of an application for resource consents to extend the Waihi Gold Mine via underground and open pit mining methods known as Project Martha

SYNOPSIS OF TECHNICAL REPORT (s42A) AND RESPONSE TO EVIDENCE BY

**Dr Cameron McKenzie
FOR THE HAURAKI DISTRICT COUNCIL**

(Blast Vibration Impact Assessment)

Figure 10 - Vibration vs scaled distance for each of the past five projects. These data have been used to develop the project specific relationships

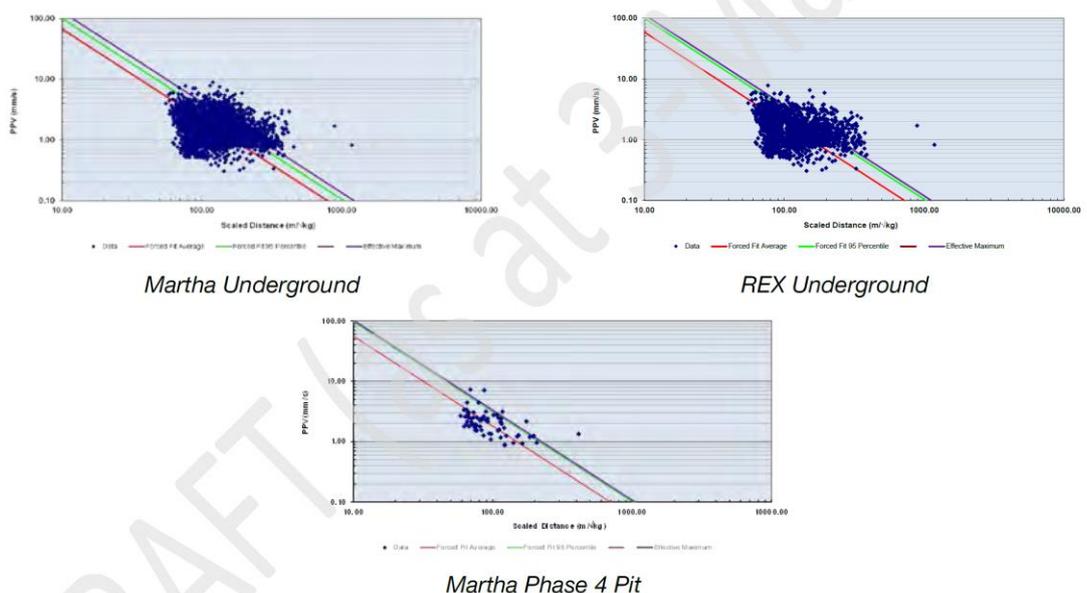
2.2.1 In his statement to commissioners on Tuesday 13 November, Dr Heilig stated that with all the historical data, the ability to predict levels now is high. I disagree with that statement, and cite Figure 10 (reproduced below) of his report dated April 2018 as justification. In those graphs, the straight lines represent the predicted values (average, 95% or effective maximum), and the blue points represent the measured values, and the large amount of scatter suggests a poor agreement between prediction and measurement. Statistically, the trend defined by the lines would have a correlation coefficient close to zero except perhaps in the case of the small and incomplete data set for Martha Phase 4 Pit.

2.2.2 I do accept, however, that the mine has convincingly demonstrated the ability to control levels to not exceed compliance levels, that is, an upper limit can be workably established within each of the data sets presented in Dr Heilig's Figure 10. I believe, firstly, that requiring compliance in terms of both average and 95 percentile vibration levels places a greater responsibility on mining personnel, during both blast design and implementation, for meticulous attention to detail, and constant review of vibration trends. A condition relating to a maximum average level effectively introduces another flag, or an orange warning light, to the design engineers and the charging crew encouraging them to take early action to avoid a non-compliance at the 95% level (the red light). Secondly, I consider it important to send the message to the Waihi community that the conditions for MP4 are no less stringent than those for Correnso. In the event that the conditions for the two operations look different, I am concerned that the difference could be interpreted as a watering-down of expectations and accountability. I fail to see that continuing with the condition relating to average values can slow down underground operations, or unnecessarily extend the duration of the project.

2.2.3 In his statement to the commissioners on Tuesday 13 November, Dr Heilig made reference to the restricted area of the Rex mining area as a reason for discontinuing the averaging condition. Rex will be challenging, but the Martha Project is more than the Rex mining activities – it also includes the Martha Underground project, for which the same issues apply as per the Correnso project. I recommend the adoption of condition 33b in the Project Martha Land Use Consent Conditions prepared by HDC.

Figure 6 - Summary of measured vibration at Main Central site for 1st January to 30th June, 2017

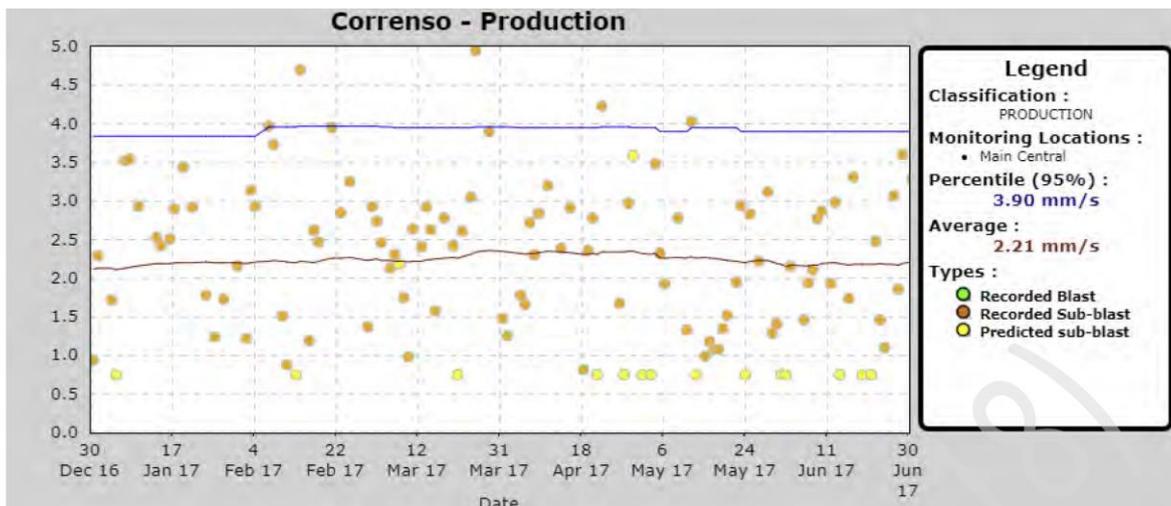
3.2 Vibration Anomalies. Dr Heilig refers in paragraph 55 of his evidence dated 28 October 2018 to the methodology for identifying an anomalous location, being where measured levels are more than 2.2 times the expected maximum levels. I agree with that definition which we jointly developed. The report refers to there being only a single instance of an anomalous location (6 Mataura Rd). In response to that statement, I recall the results of an intensive vibration monitoring programme conducted around 1988 by a US-based company, Geosonics, a prominent outcome of which was the starkly inhomogeneous nature of vibration transmission around the pit, suggesting the presence of a number of anomalous zones. Further, in Figure 6 of Dr Heilig's report dated April 2018, he presents a graph showing a portion of results from the Main Central permanent monitor over a 6 month period from 01 Jan to 30 Jun, 2017 (reproduced below). Unless I am misunderstanding the graph (and I do not understand the term Sub-blast which appears in the legend), it seems to show both predicted (yellow dots) and measured (orange dots) vibration levels, from which it seems reasonable to conclude that on many occasions measured levels are very significantly higher than predicted levels at this location, over this period of time.

3.2.1 I conclude that nobody really knows how many anomalous areas exist in the mining-affected area, and the only reason that the anomaly at 6 Mataura Rd was detected was because the readings frequently exceeded the maximum permitted level of 5 mm/s, thereby forcing a closer examination. It took several years for those data to be reviewed and confirmed as reliable. Where anomalies or higher-than-expected levels exist but are below the permitted levels, they are likely to go unnoticed or unaddressed. This conclusion, coupled with the fact that neither Dr Heilig (paragraph 56 of his Statement of Evidence) nor I fully understand the cause of the anomalous readings, makes me wary about dismissing or downplaying the possibility of future occurrences.

3.2.3 I concur with Dr Heilig's proposal in paragraphs 55 to 57 of his Statement of Evidence that the details of the path of investigation to identify anomalous areas, including the triggers for deployment of roving monitors and statistical analysis of data, be specified to the approval of HDC, OGNZL and their respective advisors, in the VMP and support condition 47a(vii) in the Project Martha Land Use Consent Conditions prepared by HDC. I also concur with Bernie O'Leary's Statement of Evidence paragraphs 61 and 62 in relation to
